Subject : Comments on Proposed Rulemaking on 10 CFR 50.46 (ECCS Acceptance Criteria)  
[RIN 3150-AH42]

**IRSN Comments on Advanced Notice of Proposed Rulemaking (ANPR)  
for Performance-Based Emergency Core Cooling System Acceptance Criteria  
(RIN 3150-AH42)**

Figure 1 : Room Temperature &  $135^{\circ}\text{C}$  Post Quench Ductility for As-Fabricated Alloys.  $17\times 17$  Zry-4 Oxidized at  $1200^{\circ}\text{C}$ ,  $800^{\circ}\text{C}$  Quench.

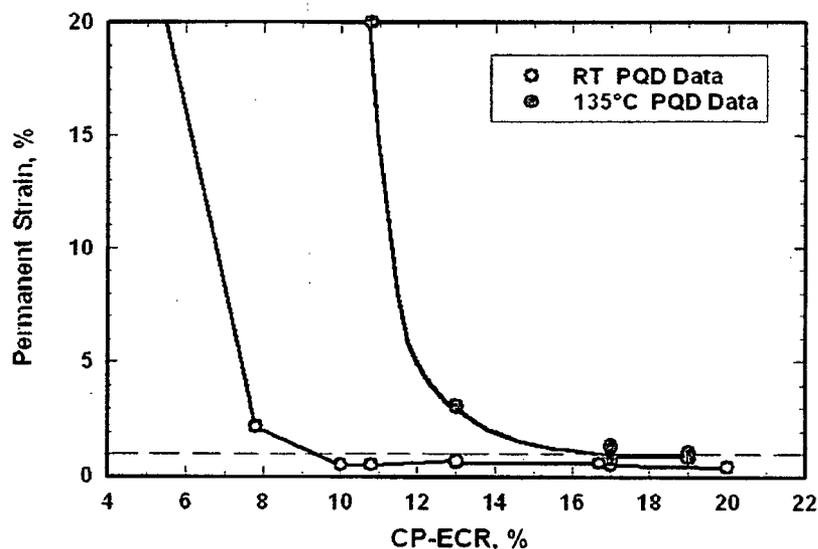
In line with ANL comments in response to this part of the ANPR, IRSN has reservations regarding the variability in results that may arise in data interpretation from testing in various labs. The question is basically linked with the shape of the permanent (or offset) strain vs. oxidation level as illustrated on Figure 1.

As the shape of the permanent strain as function of ECR shows a near horizontal branch around the low threshold value chosen to define the ductile-brittle transition (1%), significant uncertainty may be expected to locate the embrittlement threshold on the ECR parameter in the corresponding interval. In addition, variability in hydrogen content (for pre-hydrated or irradiated samples) and more or less influence of the heating rate for different target CP-ECR, make the data interpretation even more tricky. Interpolation is required to obtain the threshold value, but different techniques may be used, leading unavoidably to different results. Figure 2 illustrates the difference in threshold ECR values that was observed between data interpretation at ANL and RRC Kurchatov Institute on the same data set.

Figure 2 : Differences in ANL and RRC Interpretation of Ductile-to-Brittle Transition Oxidation Level for Same Data Set

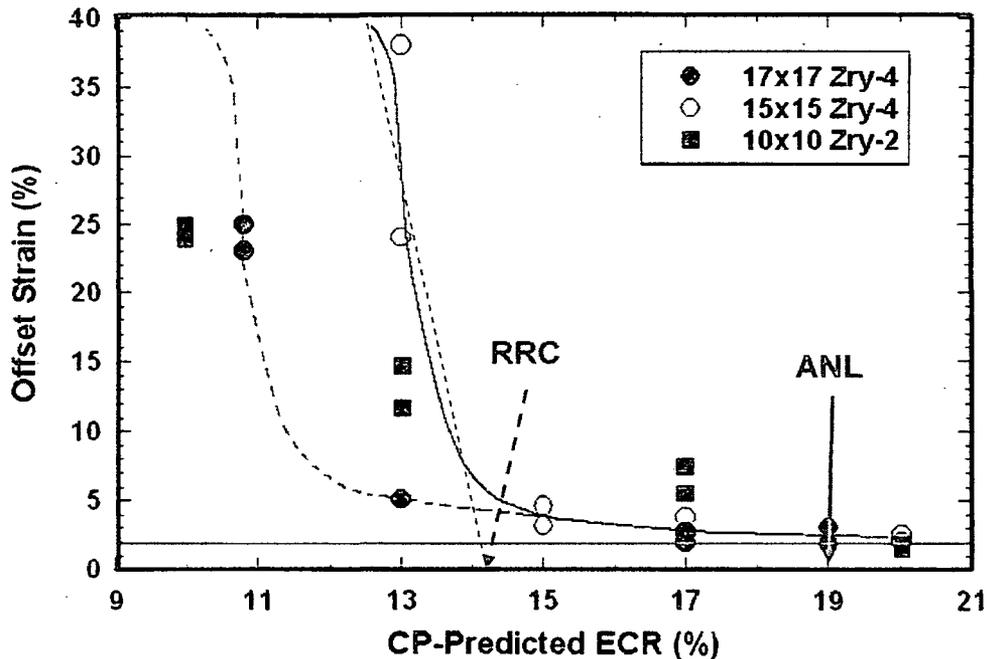
This illustration suggests that significant inconsistencies may arise between results from tests performed in different places using different test procedures and data interpretations. In view of the allowance of an approach where cladding-specific analytical limits would be defined by an applicant, the above considerations underline the need of an independent peer-review process for both test conducting and data interpretation. Such a process was efficient in the open scientific scrutiny of the LOCA research program conducted at ANL. This appears to be a necessary process so as to ensure consistency and a same level of confidence between analytical limits established in different places for different cladding alloys and/or different oxidation conditions. Ultimately, this would provide the required legitimacy to allow future adoption of the rule at an international level, as is the case for the current rule.
